LTR-NRC-15-58

Subject: Submittal of Comment for Docket ID NRC-2012-0043 on Draft Regulatory Guide DG-1263
"Establishing Analytical Limits for Zirconium Based Alloy Cladding"

**Comment for Docket ID NRC-2012-0043 on Draft Regulatory Guide DG-1263, “Establishing Analytical Limits for Zirconium Based Alloy Cladding”
(Non-Proprietary)**

Figure 1: ECR vs Hydrogen, PQD RCT Results for ZIRLO and Optimized ZIRLO Cladding

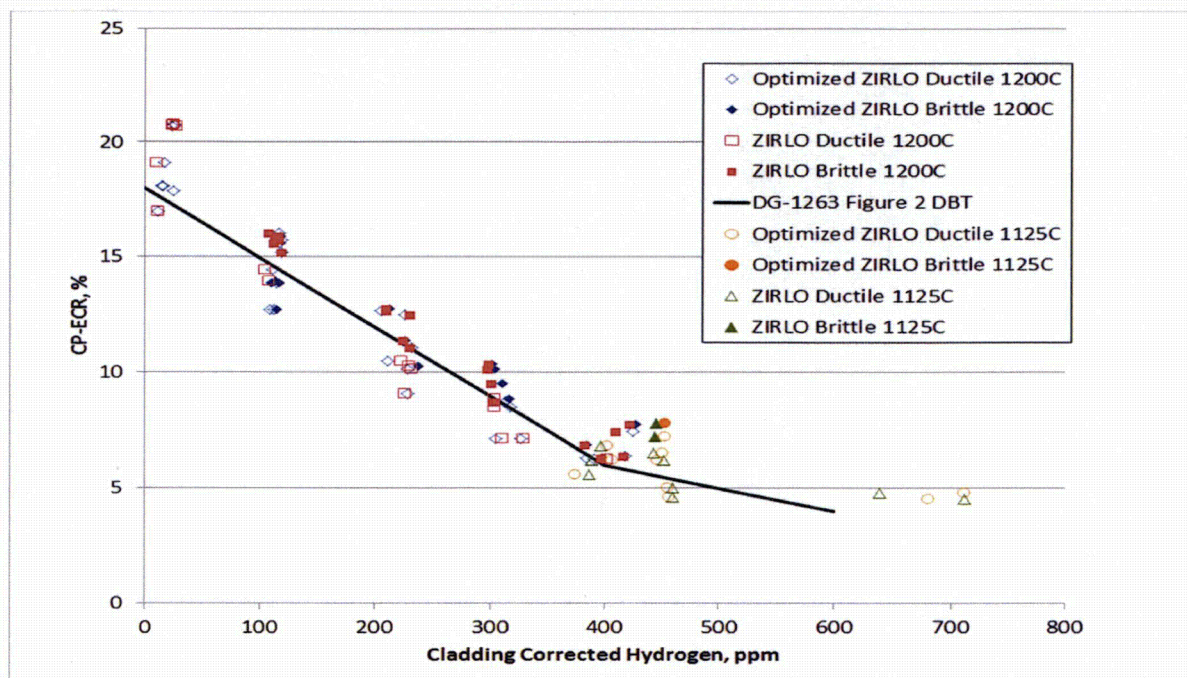
Figure 1 is a plot of Cathcart-Pawel (CP) ECR vs Hydrogen with PQD test results. Plotted are Ring Compression Test (RCT) results for ZIRLO and **Optimized ZIRLO** cladding in as-fabricated and pre-loaded with hydrogen to 100, 200, 300, 400 and 600 wppm target levels. Testing was conducted at 1200°C and 1125°C peak clad temperature. Solid symbols denote brittle results and open symbols denote ductile results. Each data point is the average of three ring compression tests with each ring cut from a common specimen of cladding following oxidation and quench. ZIRLO and **Optimized ZIRLO** cladding specimens were oxidized side by side. The average offset strain was compared to the ductile to brittle transition (DBT) offset strain correlation developed by ANL. If the average offset strain was

greater than the DBT strain, then the data point was considered ductile. If the average was equal to or less than the DBT transition developed by ANL, it was considered brittle. In a subset of RCTs, the specimen remained intact enough to allow the plastic strain to be measured. All tests for which the offset strain was greater than the ANL DBT correlation also had plastic strains greater than 1%.

Also plotted in Figure 1 is the ECR vs hydrogen DBT curve from Figure 2 in DG-1263. It can be observed that the transition from ductile to brittle generally follows that line and that the transition from ductile to brittle is nearly the same for both alloys.

Figure 2: Measured vs Predicted weight gain by Cathcart-Pawel for temperature range from 1050 to 1200°C for ZIRLO, Optimized ZIRLO and Zircaloy-4 cladding.

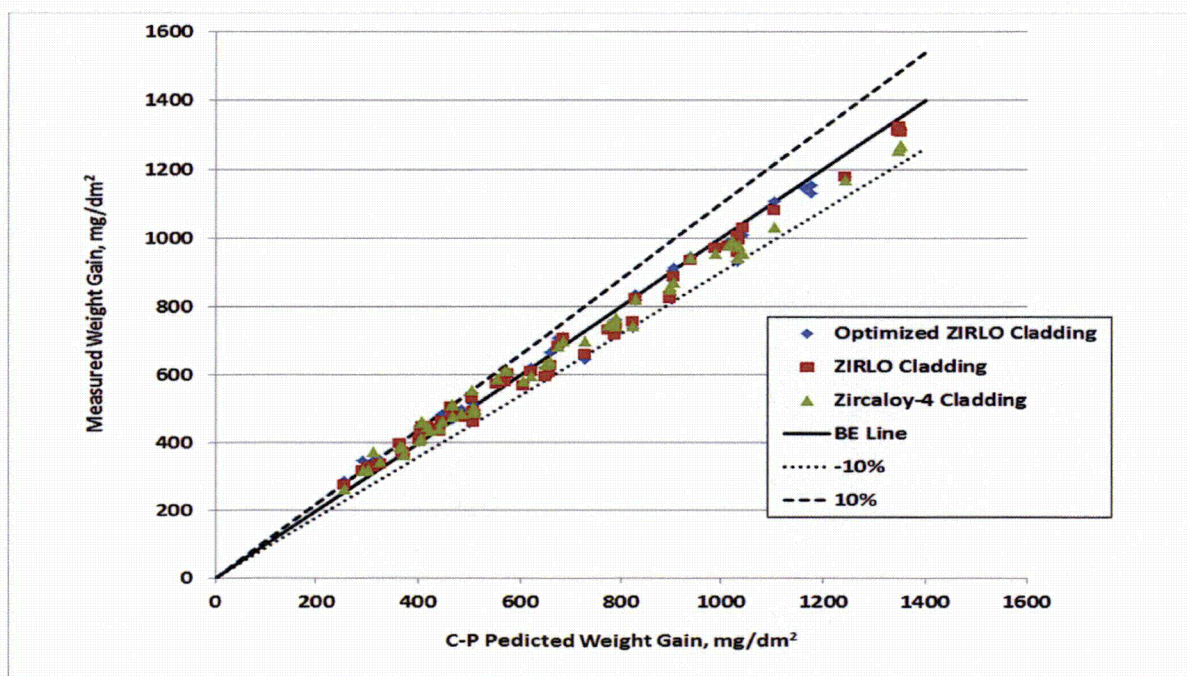
Figure 2 is a plot of measured vs predicted weight gain based on CP over the temperature range from 1050 to 1200°C for the tested ZIRLO, **Optimized ZIRLO** and Zircaloy-4 cladding. It can be observed that the weight gain is similar for the three alloys.

Figure 3: Comparison of Post Quench Cross Sections

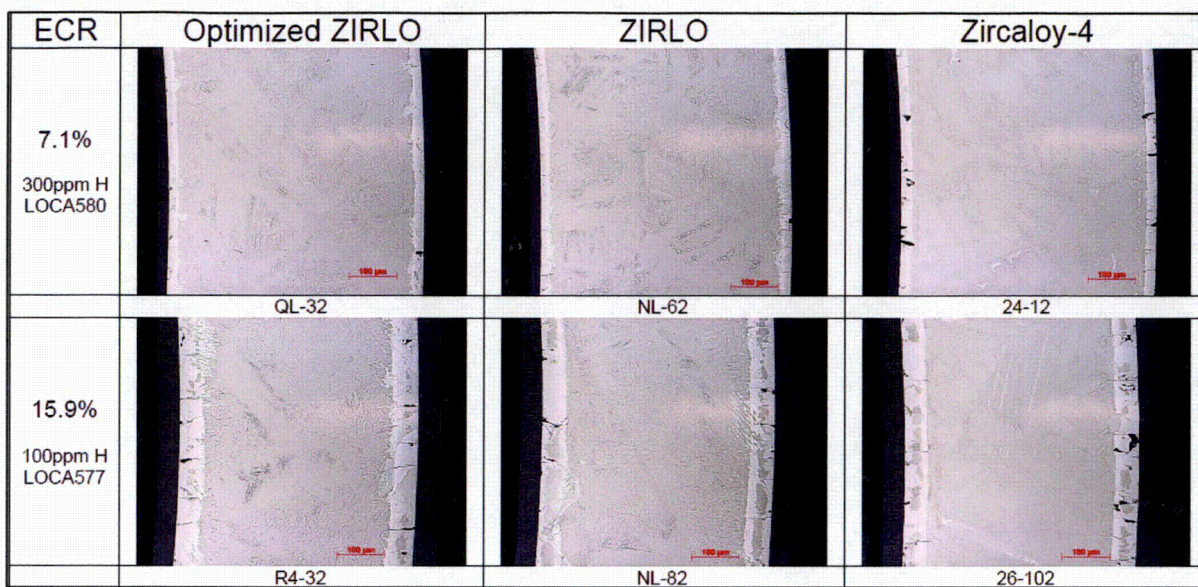
Figure 3 is a comparison of post quench macrostructure. ZIRLO, **Optimized ZIRLO** and Zircaloy-4 cladding at approximately the same ECR and hydrogen combinations have been sectioned, polished and photographed as shown in Figure 3. Two levels are shown in terms of ECR and hydrogen: 7.1% ECR and 300 wppm and 15.9% ECR and 100 wppm. It can be observed that the macrostructure in terms of oxide thickness, alpha layer thickness and remaining prior beta layer thickness at each set of conditions is very similar for the three alloys tested.
